**IS : 6639 - 1972 SPECIFICATION FOR
HEXAGON BOLTS FOR STEEL STRUCTURES**

AMENDMENT NO. 1 APRIL 1978

AMENDMENT NO. 2 OCTOBER 1981

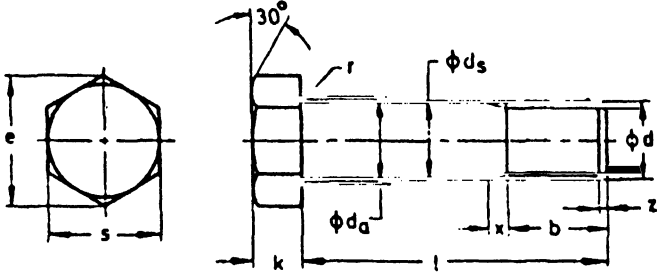
(Page 3, clause 3) - Add the following
new clause after 3:

'3.1 The bolts shall withstand a minimum
shear stress of 260 MPa.

NOTE - The shear stress specified
is explicitly intended for bolt testing
purposes and is not related to actual
design stresses.'
